**ADDENDUM NO. 3.0**

**REPLACEMENT OF INDUSTRIAL AVENUE BRIDGE (NO. 025030) OVER UNNAMED  
STREAM PROJECT  
Cheshire, Connecticut**

**Addendum No. 3 Issued February 23, 2024**

DATE: JANUARY 30, 2024

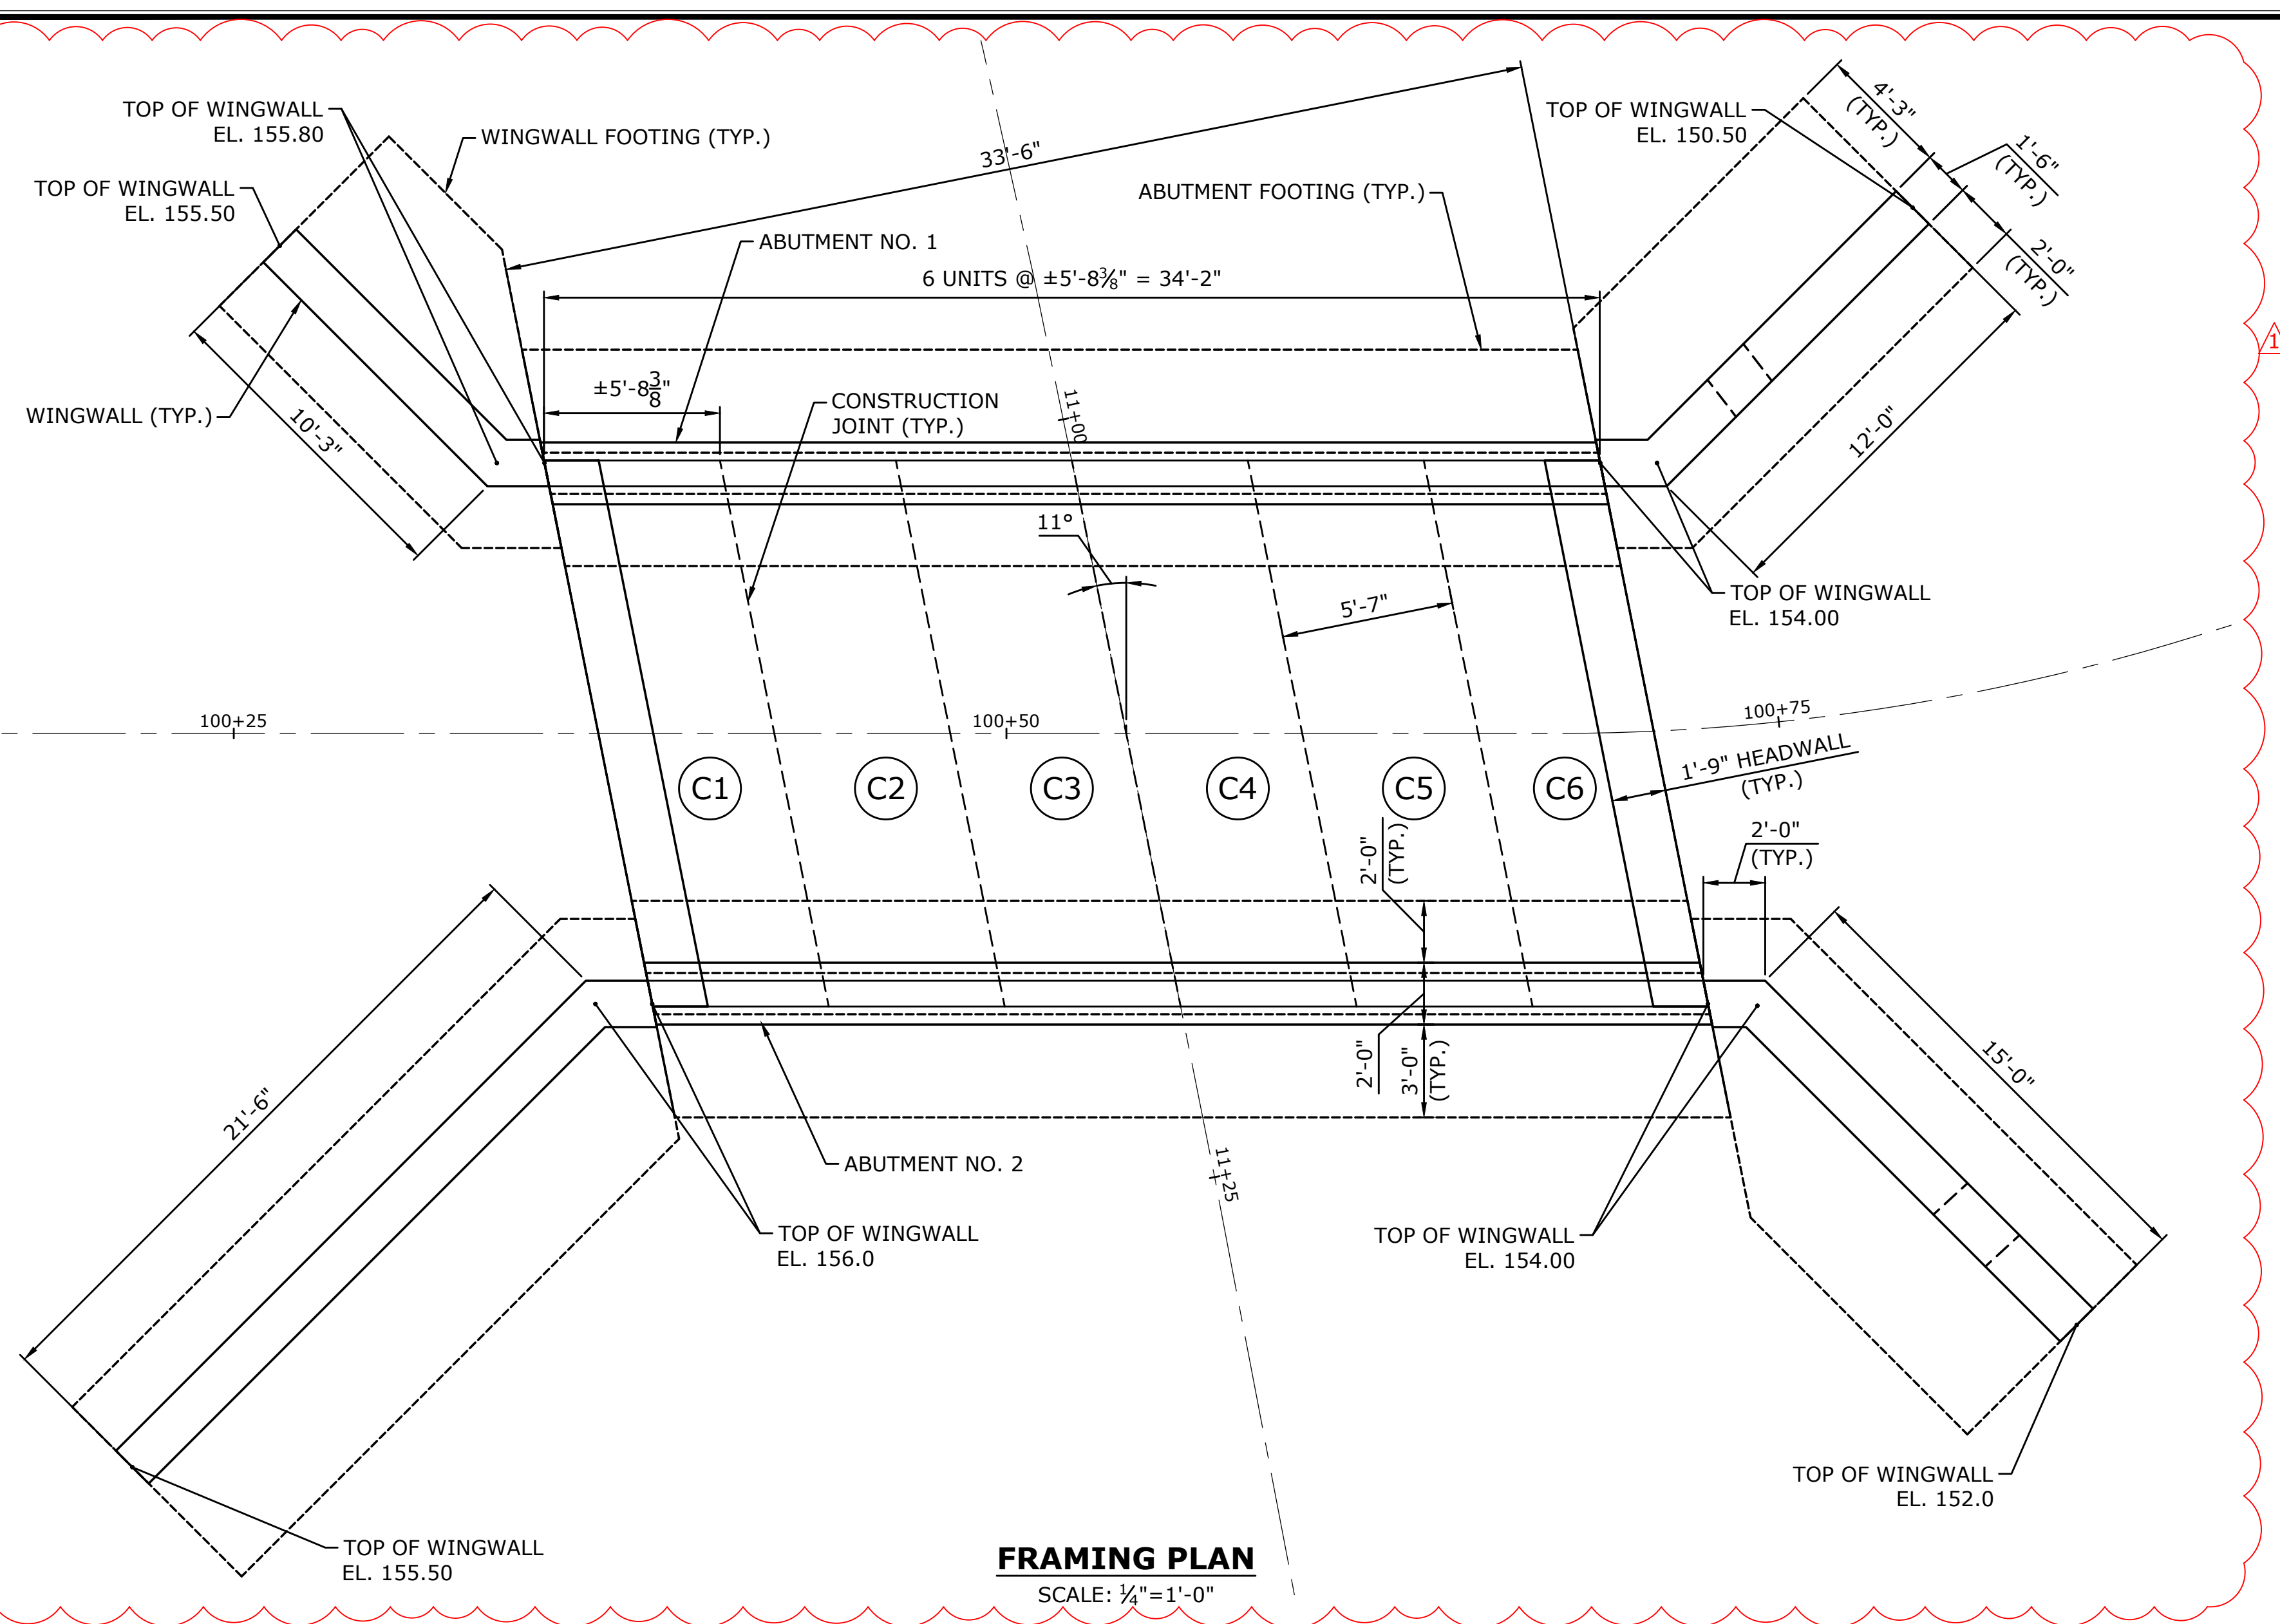
- Q5. Please provide the elevations at the top of the wingwalls as well as the detail for where the drainage pipes pass through the wingwall.**
- R5. See updated plan sheet STR-03.

**TYPICAL WATER MAIN SUPPORT DETAIL**

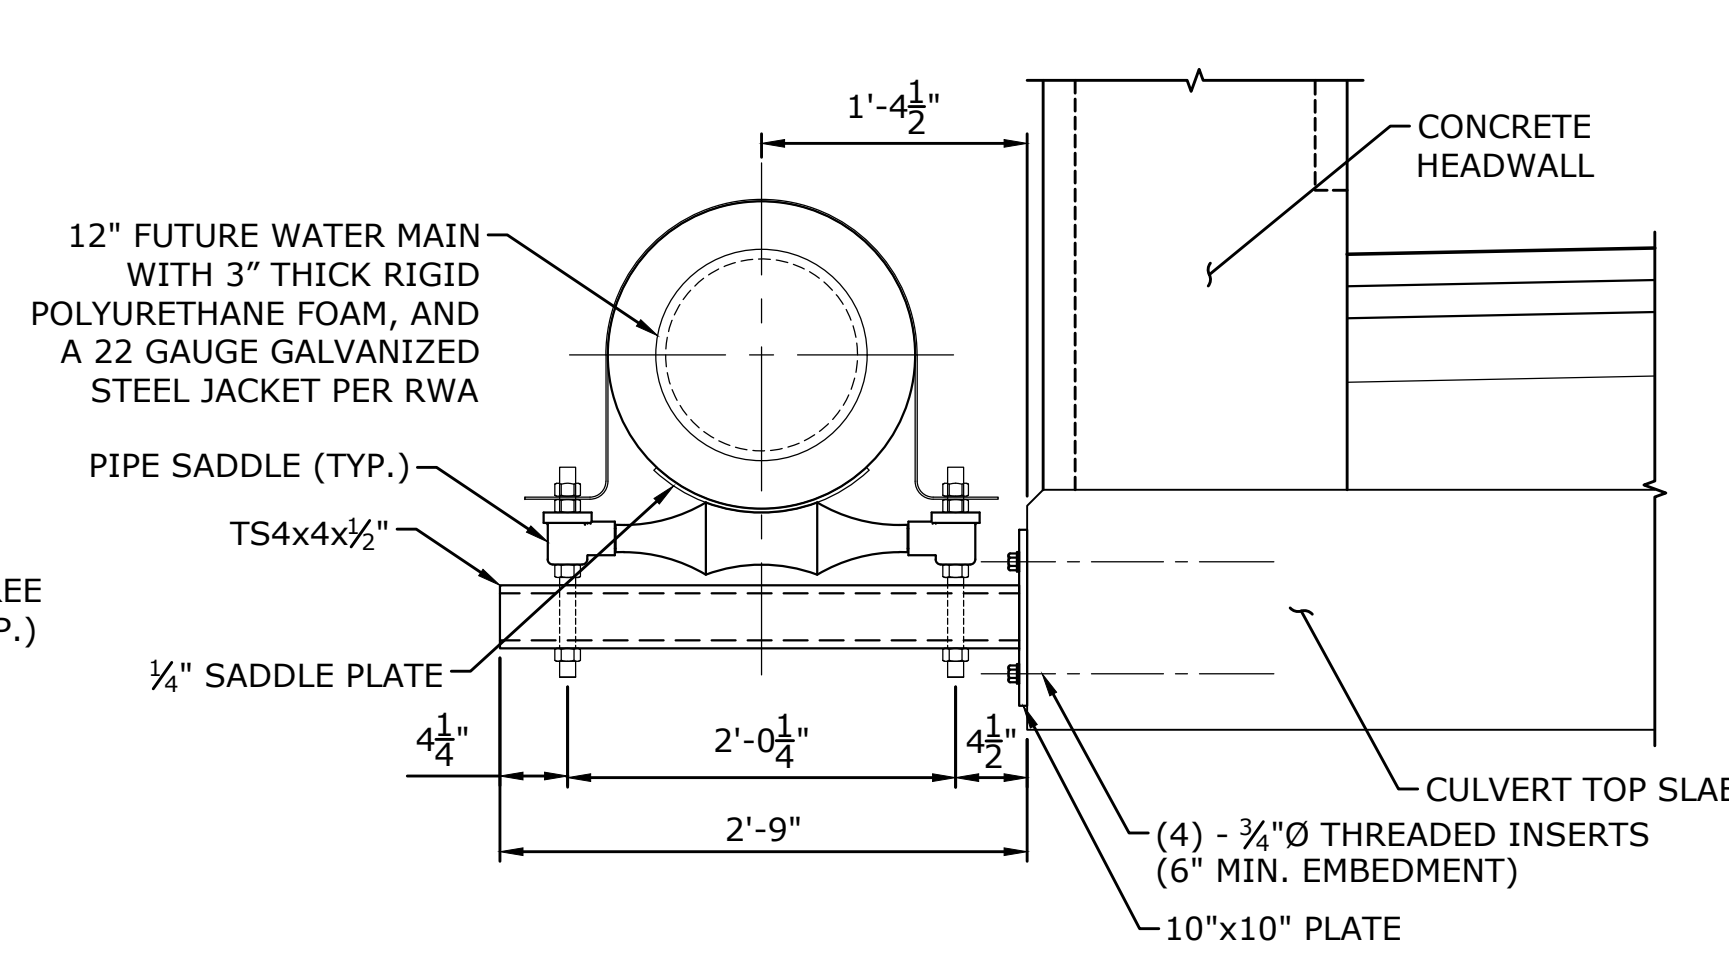
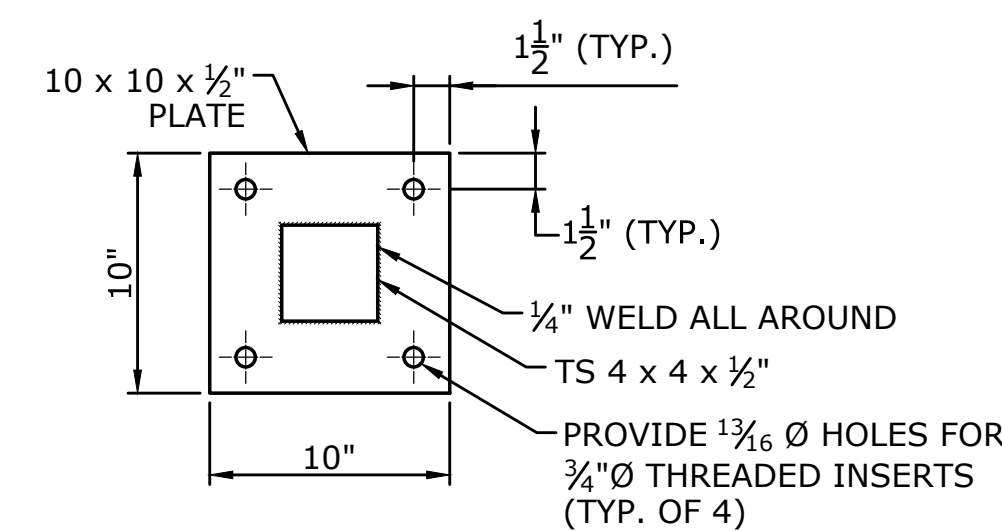
**Q1. ITEM #1401257A – WATER MAIN SUPPORT BRACKETS:** The item is paid for as a lump sum item, but we cannot locate a quantity or spacing on the plans to allow us to price this item as a lump sum item, can you tell me the quantity of these supports that are required?

R1. See revised sheet 12, STR-03, downstream parapet detail.
